**RESOLUTION BY THE PUBLIC WORKS/CAPITAL IMPROVEMENTS AND
STORMWATER/WASTEWATER COMMITTEE APPROVING AND RATIFYING
ADDITIONAL WORK FOR THE 2022 STREET PAVING PROGRAM**

CHANGE ORDER NO. 1

Date of Issuance: 7/24/22		Effective date: 7/24/22
Project: 2022 Sturtevant Paving Program	Owner: Village of Sturtevant	Owner's Contract No.:
Contract:		Date of Contract:
Contractor: Asphalt Contractors, Inc.		Engineer's Project No.: 2211124

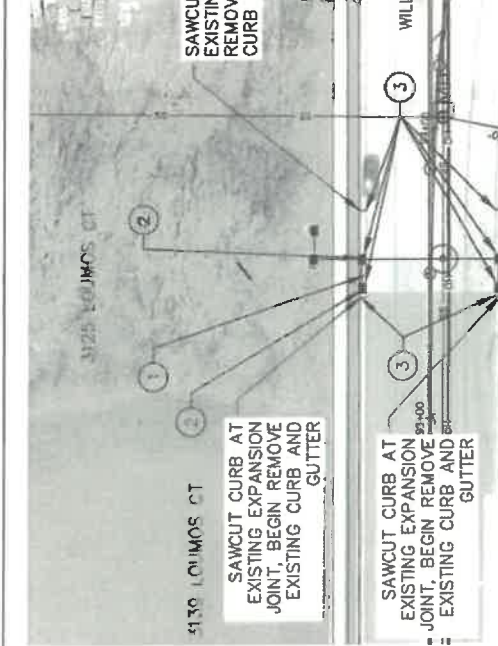
Post bid an addition to the project of heaved catch basins.

- 1 PROTECT STRUCTURES FROM SEDIMENT DUE TO CONSTRUCTION ACTIVITIES. REMOVE AND REPLACE EXISTING CURB AND GUTTER - 30" TYPE A - NO. 4 X 2"-Ø THE BARS SPACED AT 3'-0" C-C PER SDD 08D01-b. SAWCUTTING REQUIRED BETWEEN EXISTING CURB AND GUTTER AND PAVEMENT.
- 2 REMOVE AND REPLACE TYPE H (R-3067L) INLET COVER (FRAME AND GRATE). REMOVE AND REPLACE EXISTING ADJUSTMENT RINGS AND BACK PLASTER. REMOVE AND REPLACE ALL MOTOR AND BACKPLASTERING AROUND INCOMING AND OUTGOING PIPES WITHIN STRUCTURE AS NECESSARY TO ENSURE SEALED STRUCTURE/PIPE INTERFACE TO THE INSIDE OF THE STRUCTURE.
- 3 INSTALL EXPANSION JOINTS (NONAFLEX OR APPROVED EQUAL MEETING OR EXCEEDING ASTM D8139 & DS45) MINIMUM LOCATIONS ARE AT SOUTH SAWCUT LOCATION, NORTH SAWCUT LOCATION AND NORTH SIDE OF EACH INLET CASTING (4 EXPANSION JOINTS PER SIDE OF WILLOW ROAD).
